Project: 90009590 - I-405 - Brickyard to SR527  
 Bothell, Washington 98011

## BY-CRE-03798\_009727\_RFI\_00627\_16.03.02\_BRT Below Grade Waterproofing Revisions Missed Prior to RFC

Washington State Department of Transportation  I-405, Brickyard to SR 527 Improvement Project Contract No. 009727	Doc Type: RFI
		REV#: 0
		SPEC SECTION:
		DATE: 10/22/2025
		CRE #: BY-CRE-03798

**ELEVATOR SHAFT SECTION DETAIL 5**  
SCALE: 1 1/2" = 1'-0" BT230-AVX100

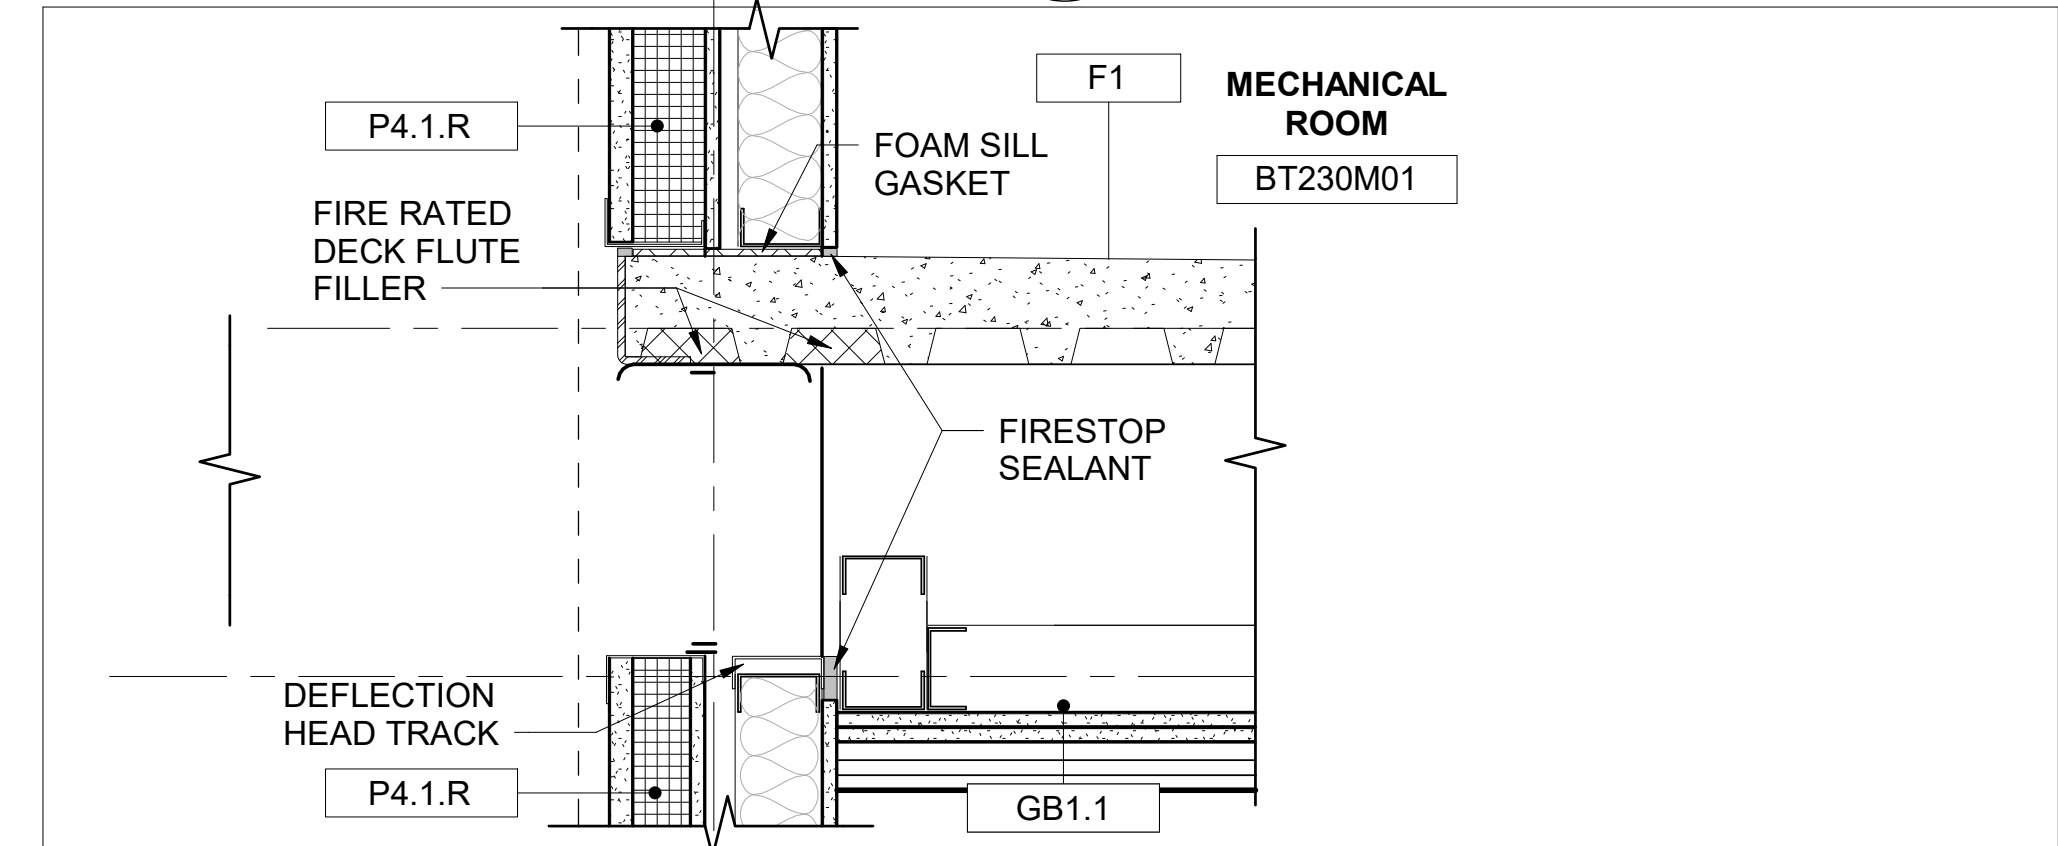
Q. AECOM please confirm all below grade waterproofing that has been marked on the attached drawings should have been removed prior to RFC.

**AECOM response:** Yes, waterproofing should be removed in marked up areas to be consistent with section AVX150 and AEX series where the waterproofing was omitted.
